**PURPOSE STATEMENT**  
FOR REVISION #5  
THE PURPOSE OF THIS REDLINE IS TO ADD 13,29'x40' BATHROOM EXPANSION TO THE EX. COMMUNITY BUILDING, HANDICAP SPACE, CONCRETE STOOP AND REVISE THE STORMWATER MANAGEMENT FACILITY.

**PURPOSE STATEMENT**  
FOR REVISION #6  
THE PURPOSE OF THIS REDLINE IS TO REPLACE THE EXISTING POOL DECK (TRAINING POOL, ADD STORMWATER FACILITIES & DETAILS.

**PROJECT TITLE:** LOUGHELOW NEIGHBORHOOD CENTER 5TH ELECTION DISTRICT, HOWARD COUNTY  
SUBJECT: M 29 2731, LOT 1, 2, 3

**AS-BUILT SITE PLAN**

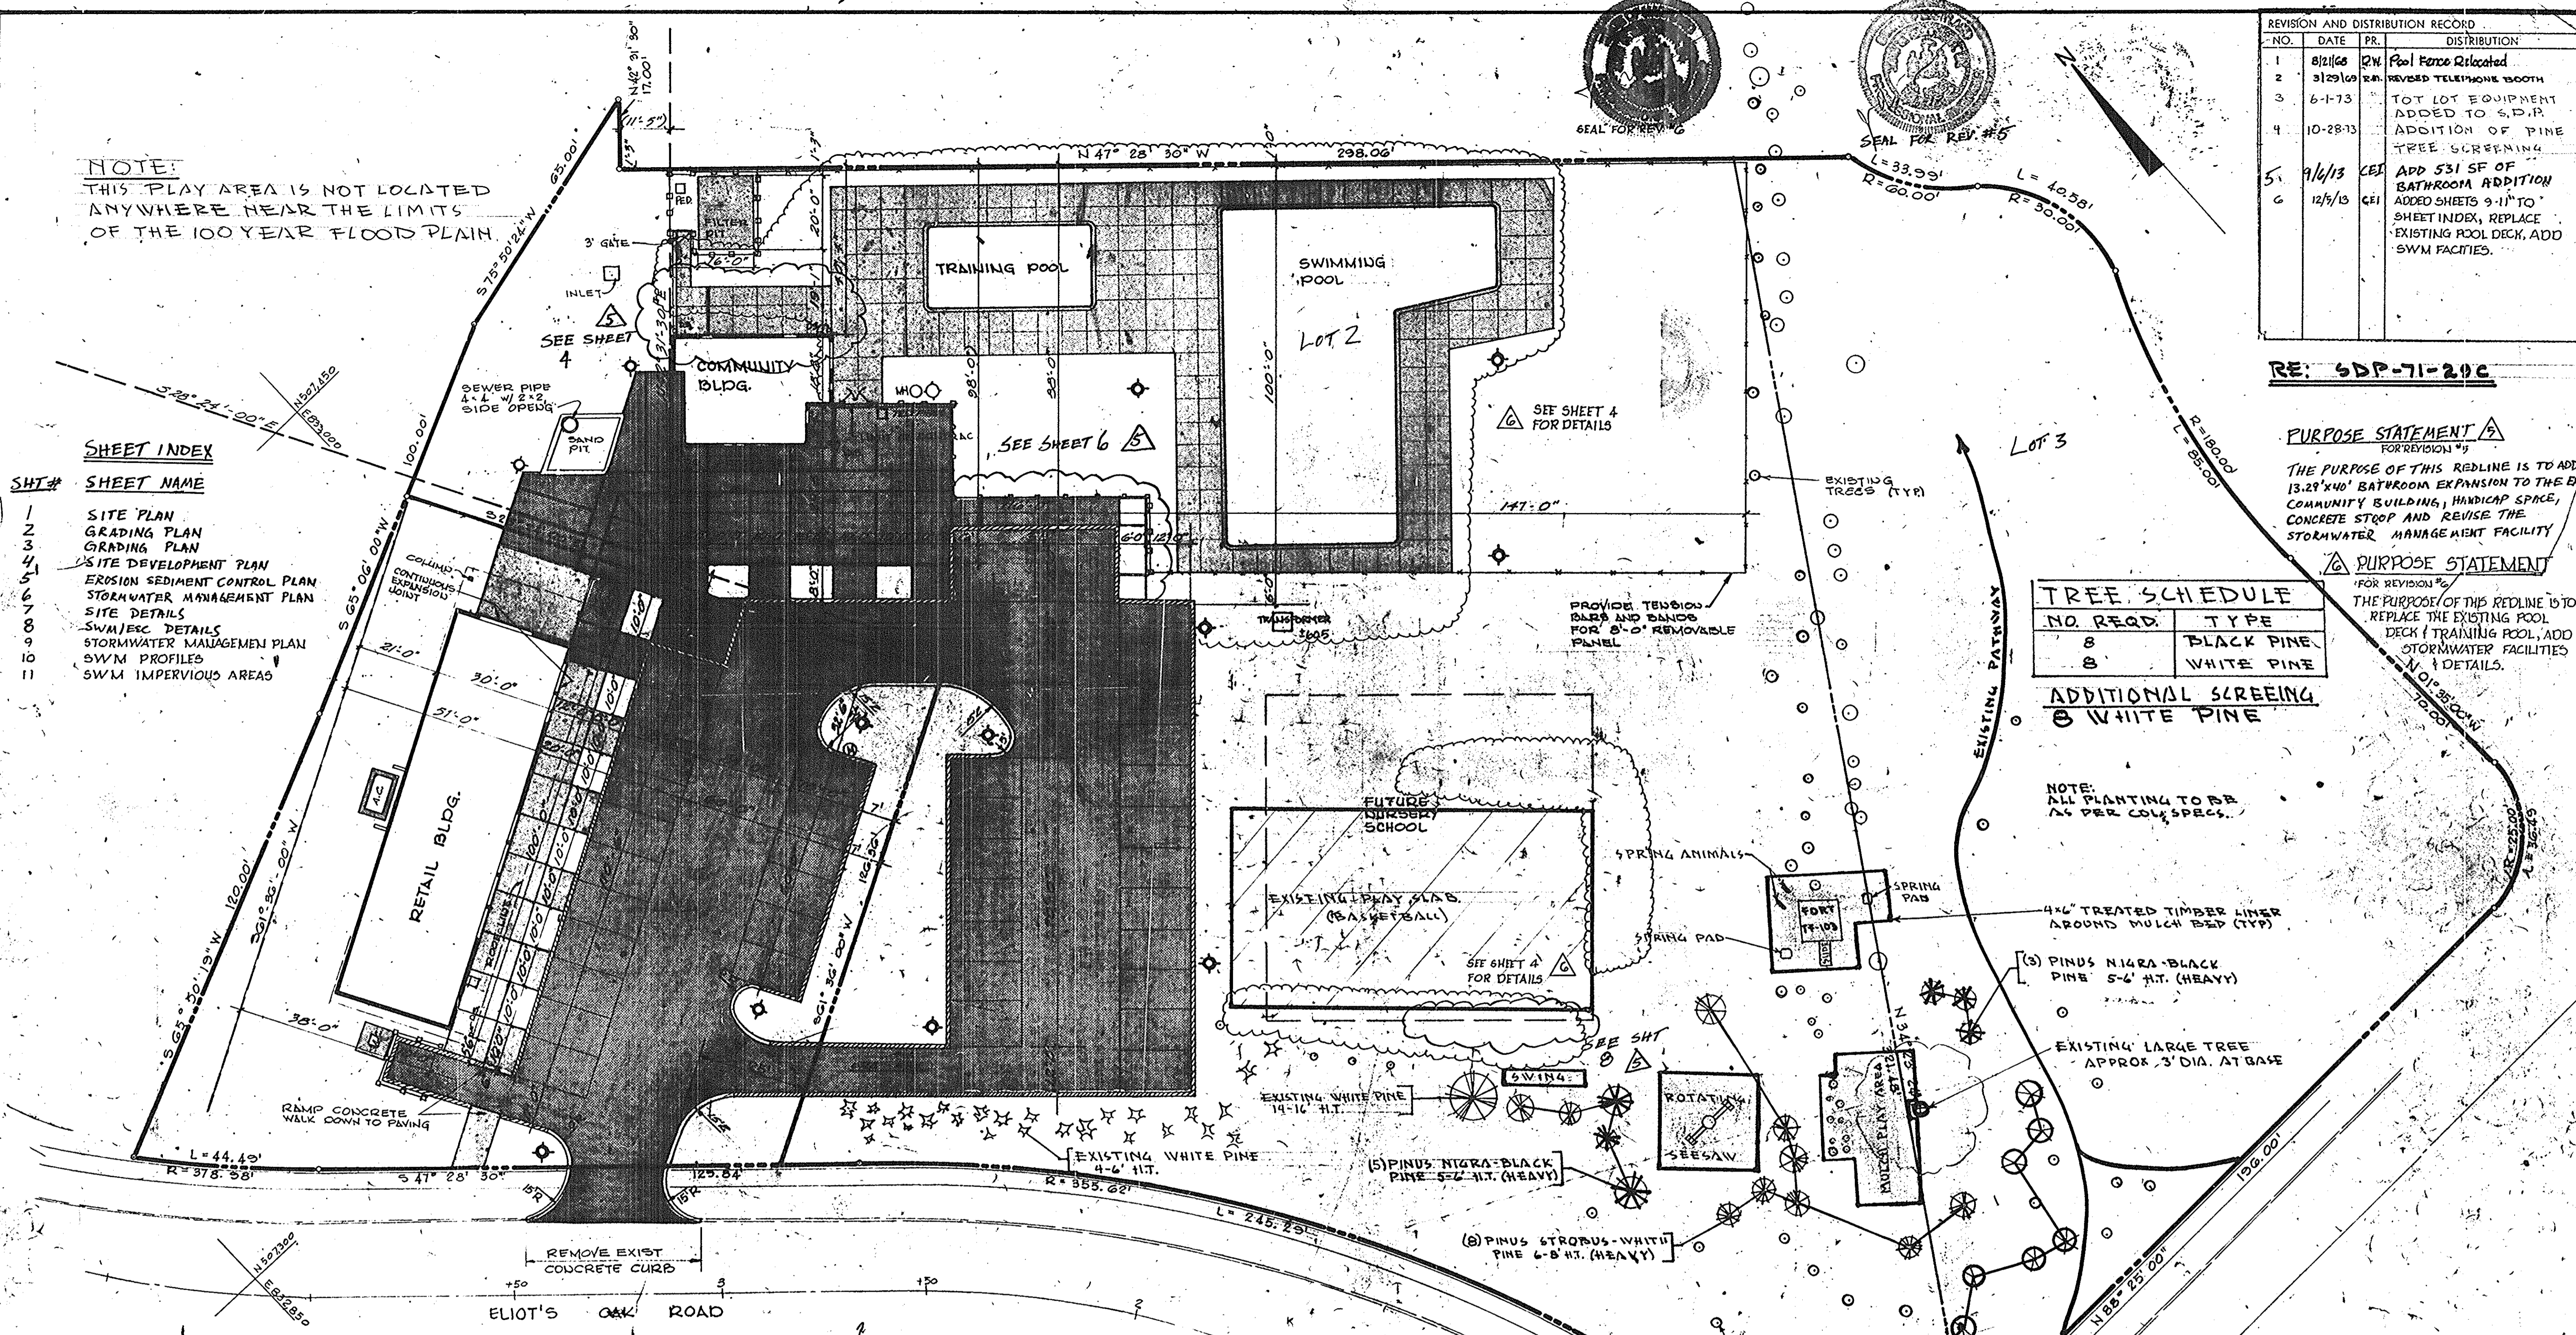
REVISION AND DISTRIBUTION RECORD			
NO.	DATE	PR.	DISTRIBUTION
1	8/21/68	RW	Pool Fence Relocated
2	3/29/69	RW	REVISED TELEPHONE BOOTH
3	6-1-73		TOT LOT EQUIPMENT ADDED TO S.D.P.
4	10-28-73		ADDITION OF PINE TREE SCREENING
5	9/6/73	CEI	ADD 531 SF OF BATHROOM ADDITION
6	12/5/73	CEI	ADDED SHEETS 9-11 TO SHEET INDEX, REPLACE EXISTING POOL DECK, ADD SWM FACILITIES.

PROJECT TITLE:  
LONGFELLOW NEIGHBORHOOD CENTER  
SITE ELECTION DIST. HOWARD COUNTY  
SUBJECT: TM 29 LOT 273 Lots 1, 2 & 3  
GRADING PLANS BY R.W.C.

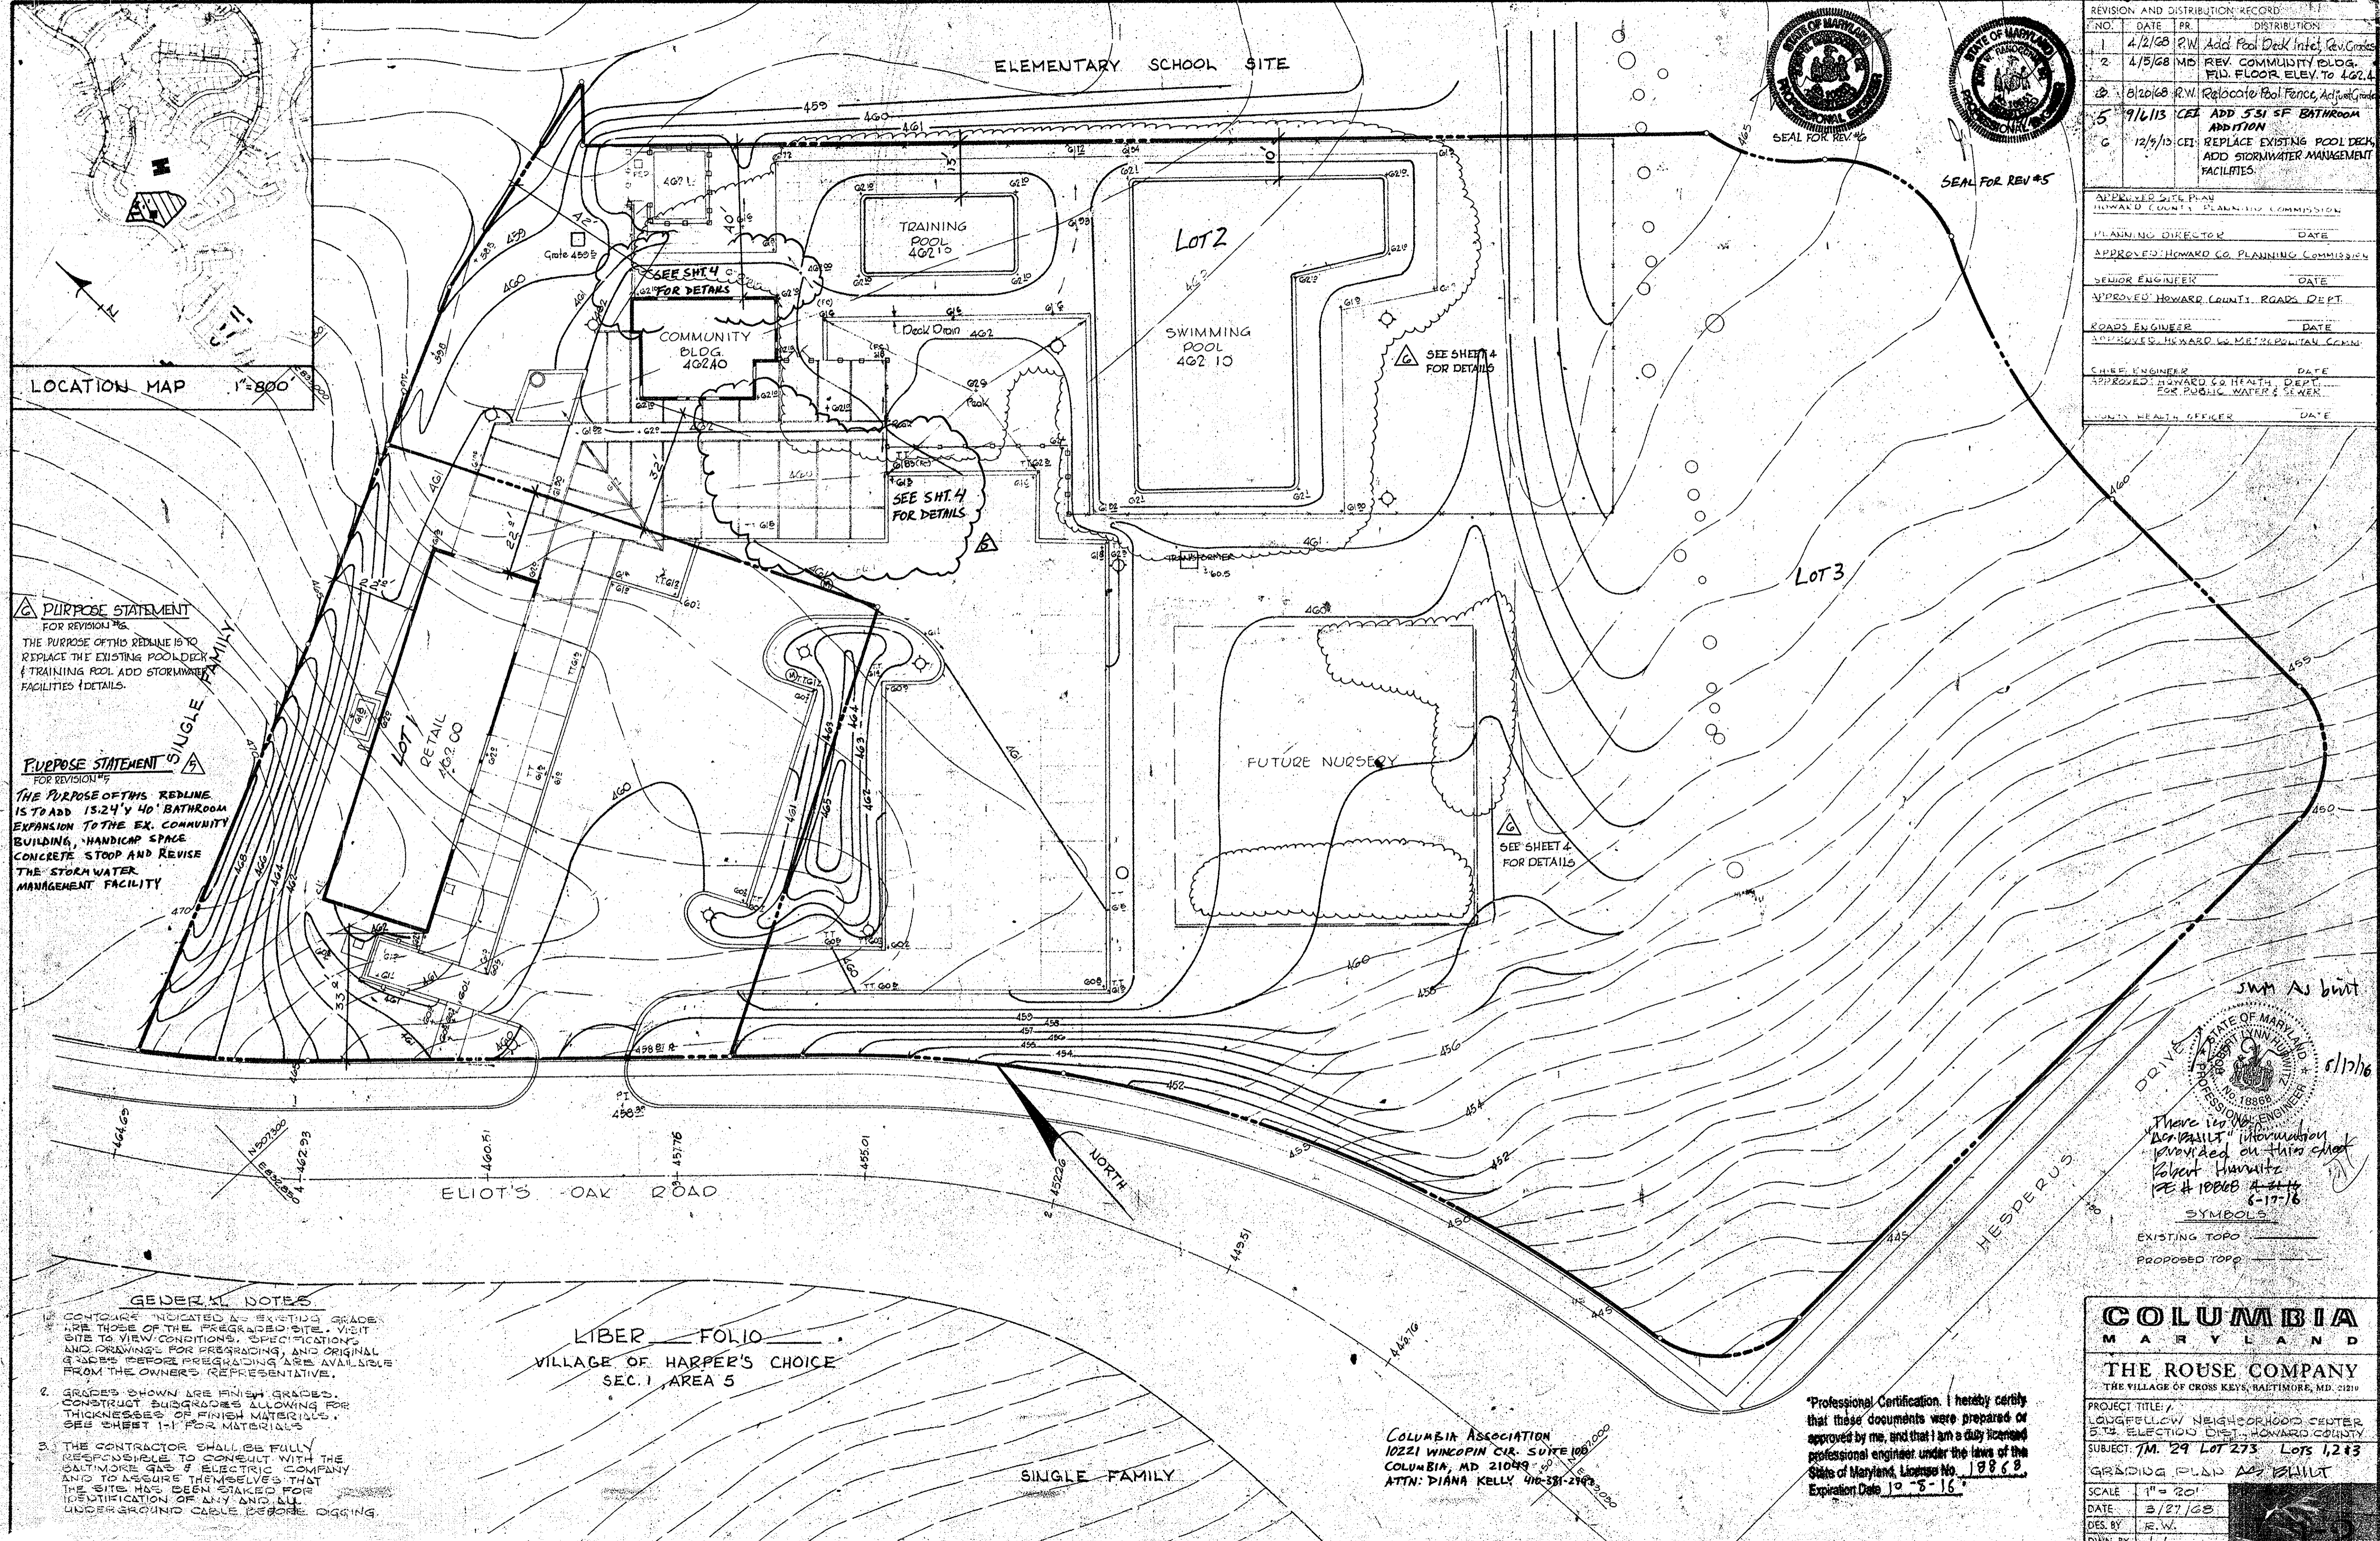
REVISION AND DISTRIBUTION RECORD			
NO.	DATE	PR.	DISTRIBUTION
1	4/2/68	R.W.	Add Pool Deck Int'l. Rev. Grades
2	4/5/68	MD	REV. COMMUNITY BLDG. FLD. FLOOR ELEV. TO 462.4
3	8/20/68	R.W.	Relocate Pool Fence, Adjust Grades
5	9/16/13	CEI	ADD 531 SF BATHROOM ADDITION
6	12/5/13	CEI	REPLACE EXISTING POOL DECK, ADD STORMWATER MANAGEMENT FACILITIES

**PURPOSE STATEMENT**  
FOR REVISION #6  
THE PURPOSE OF THIS REDLINE IS TO REPLACE THE EXISTING POOL DECK & TRAINING POOL. ADD STORMWATER FACILITIES (DETAILS).

**PURPOSE STATEMENT**  
FOR REVISION #5  
THE PURPOSE OF THIS REDLINE IS TO ADD 15.24' x 40' BATHROOM EXPANSION TO THE EX. COMMUNITY BUILDING, HANDICAP SPACE, CONCRETE STOOP AND REVISE THE STORM WATER MANAGEMENT FACILITY.

PROJECT TITLE: LOGG FELLOW NEIGHBORHOOD CENTER 5<sup>TH</sup> ELECTION DIST. HOWARD COUNTY  
SUBJECT: T.M. 29 P.273 LOTS 1,2 & 3  
GRADING PLAN APPROVAL

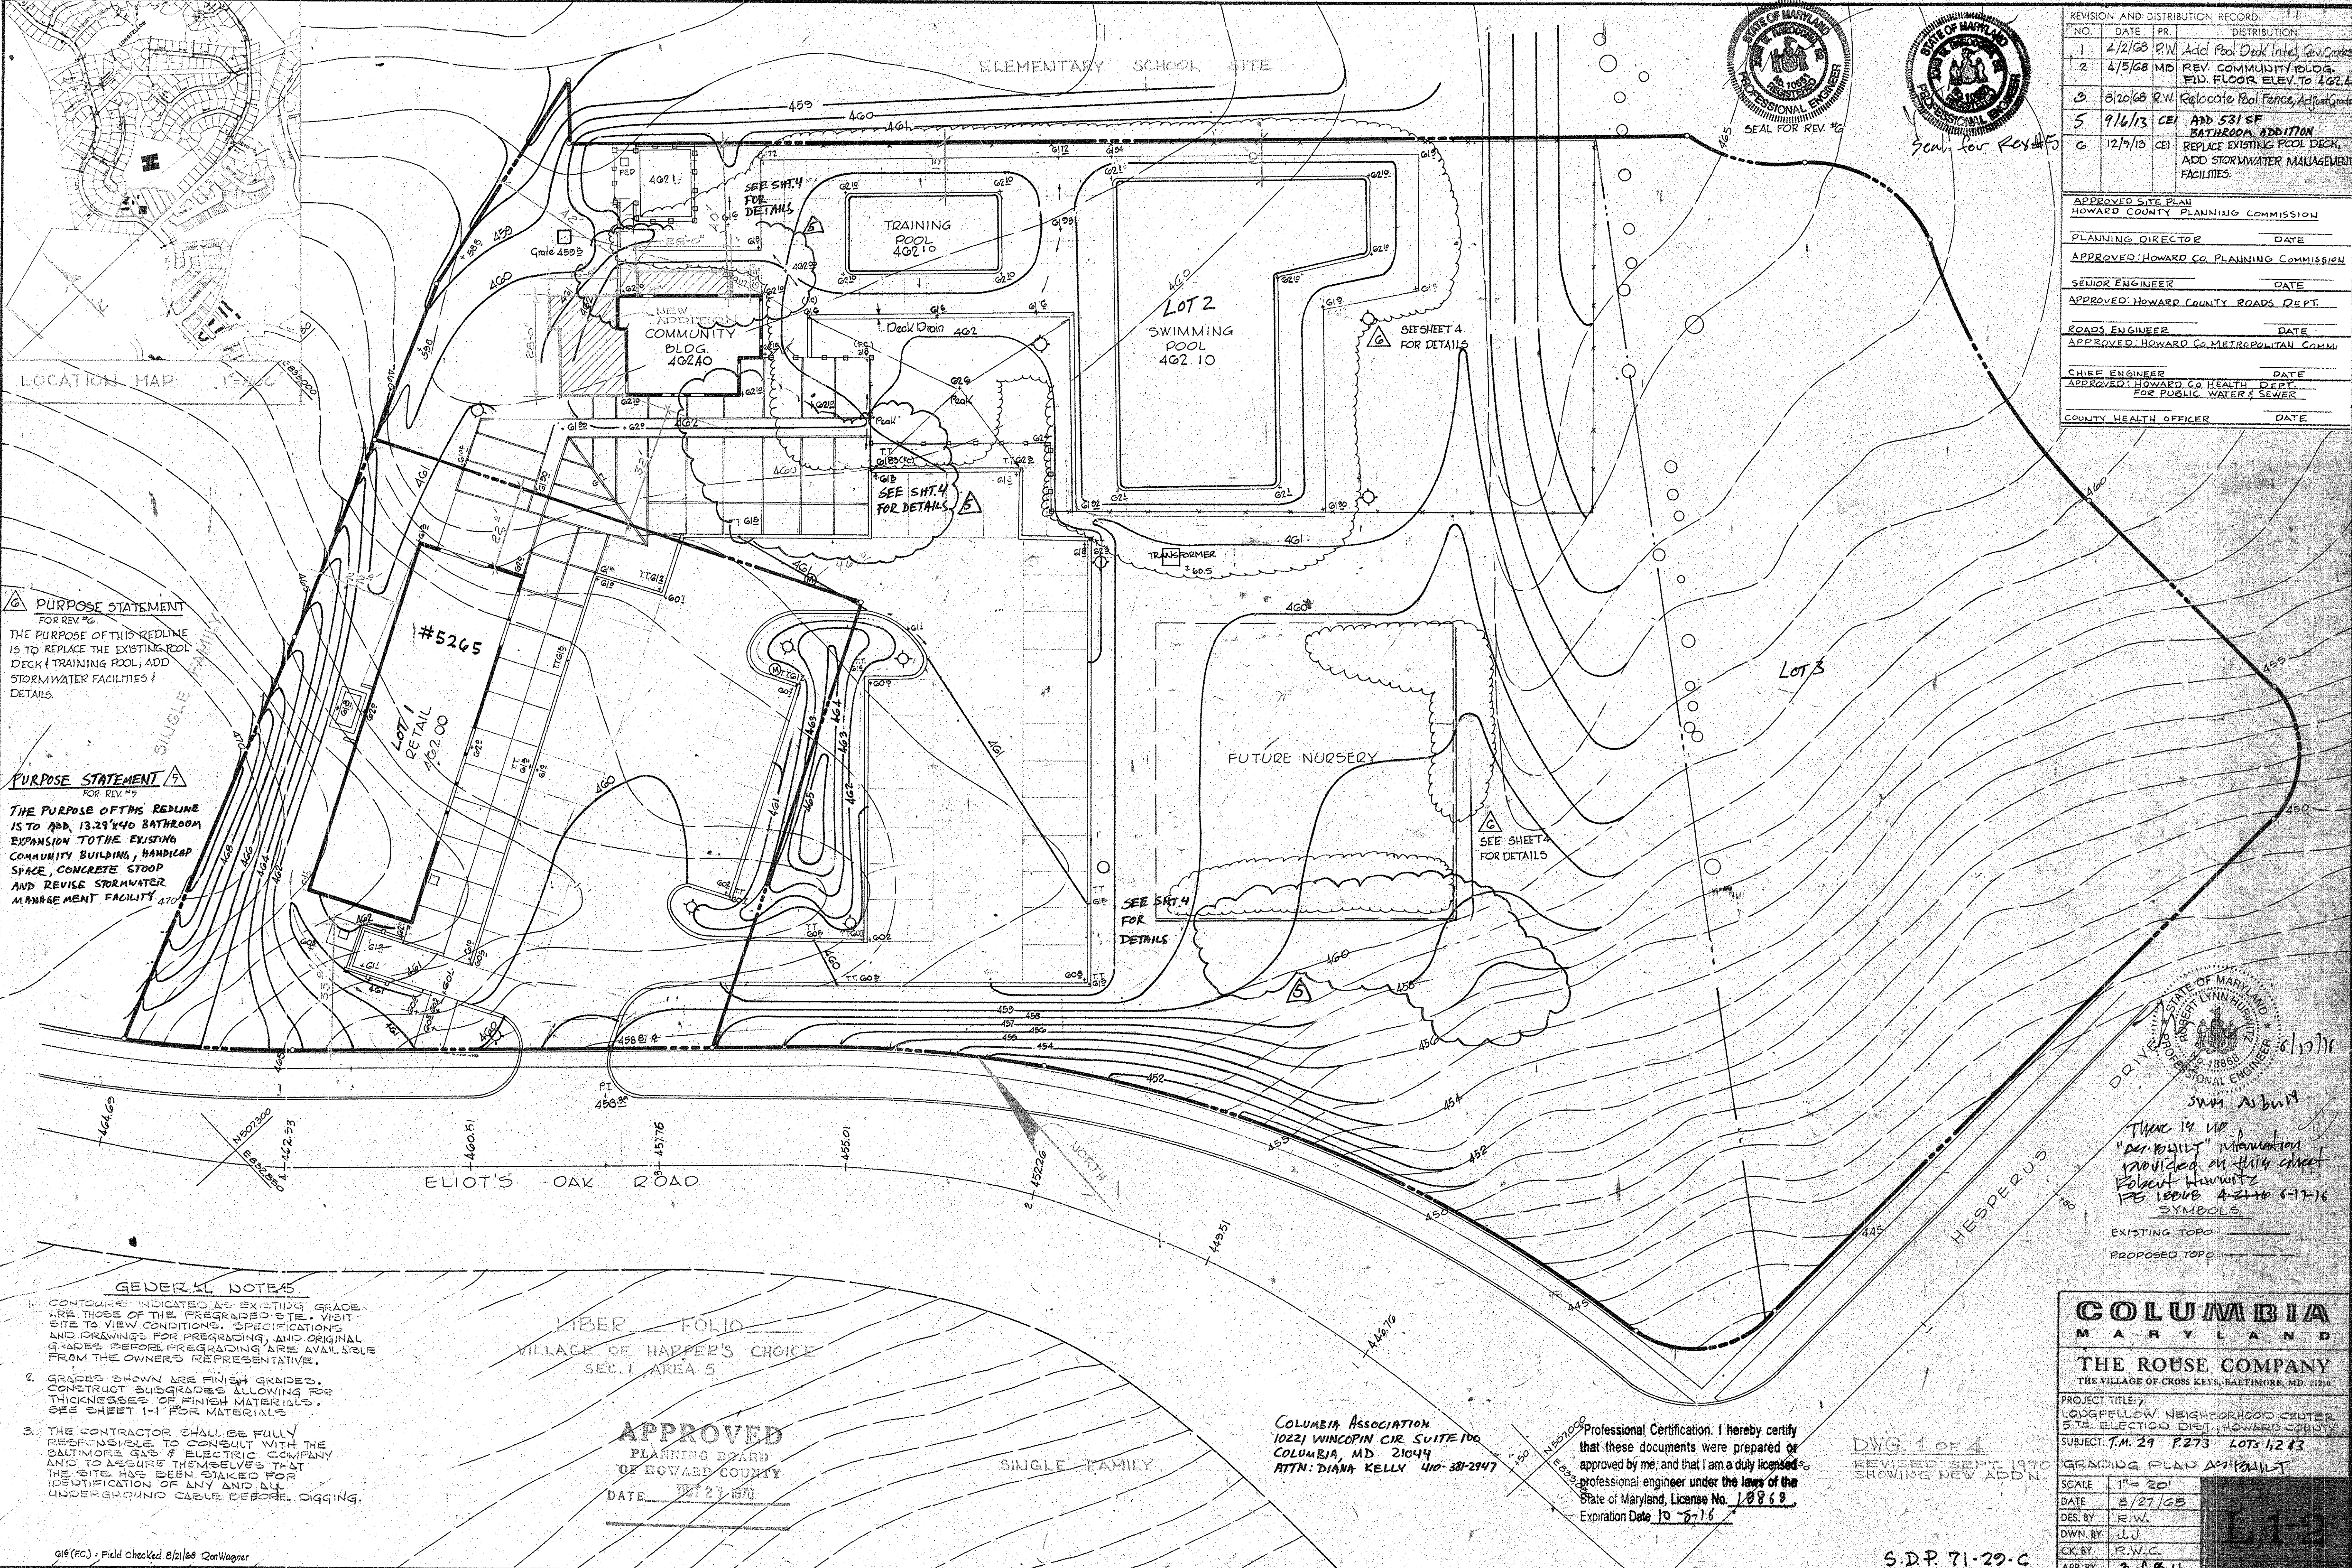
REVISION AND DISTRIBUTION RECORD			
NO.	DATE	PR.	DISTRIBUTION
1	4/2/68	R.W.	Add Pool Deck Intst, Rev. Grades
2	4/5/68	M.D.	REV. COMMUNITY BLDG. FLD. FLOOR ELEV. TO 462.4
3	8/20/68	R.W.	Relocate Pool Fence, Adjust Grades
5	9/16/73	CEI	ADD 531 SF BATHROOM ADDITION
6	12/7/73	CEI	REPLACE EXISTING POOL DECK, ADD STORMWATER MANAGEMENT FACILITIES.

**PURPOSE STATEMENT**  
FOR REV #6  
THE PURPOSE OF THIS REDLINE IS TO REPLACE THE EXISTING POOL DECK & TRAINING POOL, ADD STORMWATER FACILITIES & DETAILS.

**PURPOSE STATEMENT**  
FOR REV #9  
THE PURPOSE OF THIS REDLINE IS TO ADD 13.29'x40' BATHROOM EXPANSION TO THE EXISTING COMMUNITY BUILDING, HANDICAP SPACE, CONCRETE STOOP AND REVISE STORMWATER MANAGEMENT FACILITY.
